8. Well Name and No.
Arcturus 18 Federal 2H

DEVON ENERGY
DRILLING SUNDRY – PRESET SURFACE CASING
MHC 3.7.11

Arcturus 18 Federal 2H
30-015-38390
Devon Energy Production Company, L. P.
14 March 2011
Conditions of Approval

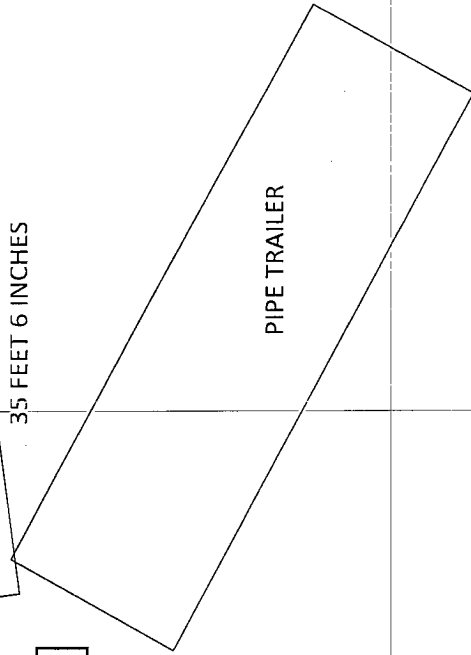
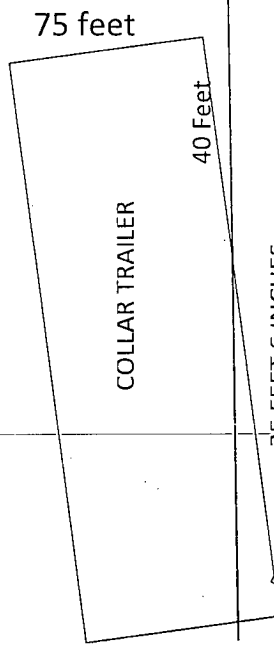
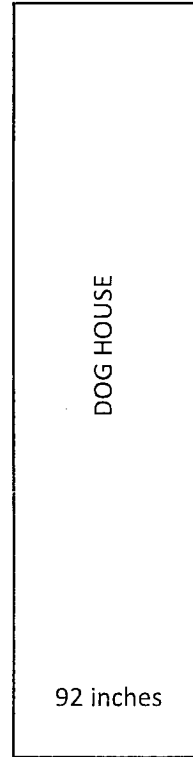
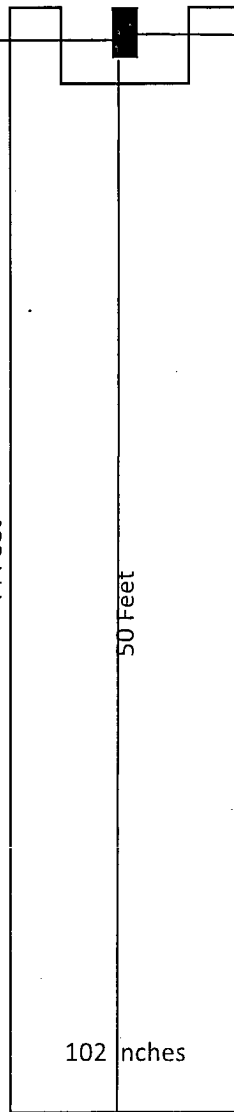
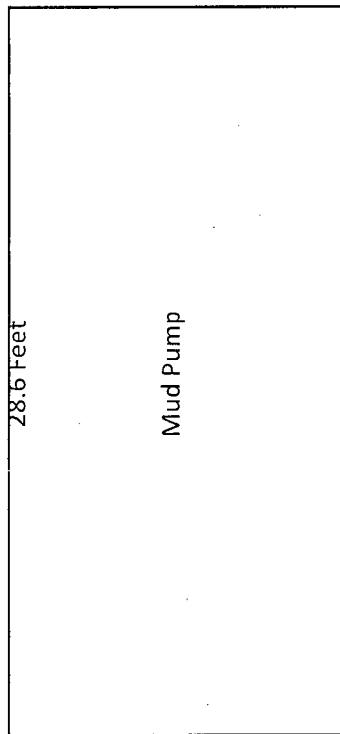
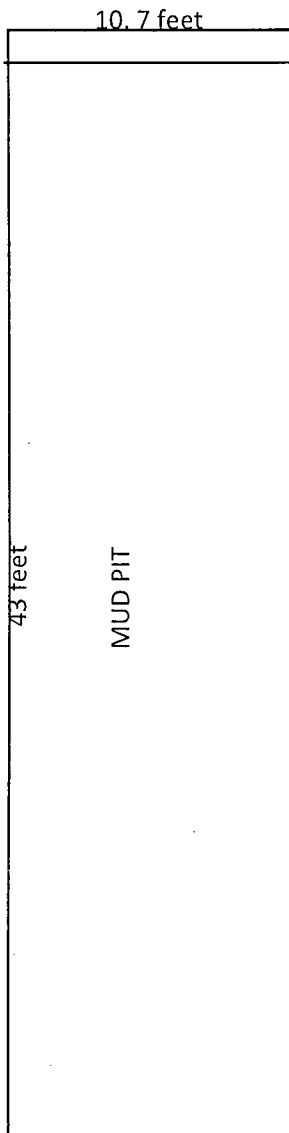
The surface casing will be set using an Ashton Oilfield Services rig. The rig plat is attached.

1. Surface disturbance beyond the originally approved pad must have prior approval.
2. Option – Setting surface casing with Ashton Rig
 - a. Notify the BLM when removing the Ashton Oilfield Services Rig.

- b. Notify the BLM when moving in the H&P Flex Rig. Rig to be moved in within 60 days of notification that Ashton Oilfield Services Rig has left the location. Failure to notify or have rig on location within 60 days will result in an Incident of Non-Compliance.

- c. Once the H&P Flex Rig is on location, it shall not be removed from over the hole without prior approval unless the production casing has been run and cemented or the well has been properly plugged. **If the drilling rig is removed without approval – an Incident of Non-Compliance will be written and will be a “Major” violation.**

- d. BOP/BOPE test to be conducted per Onshore Oil and Gas Order No. 2 as soon as H&P Flex Rig is rigged up on well. CIT for the surface casing shall be performed and results recorded on subsequent sundry – pressure to be 1200 psi.
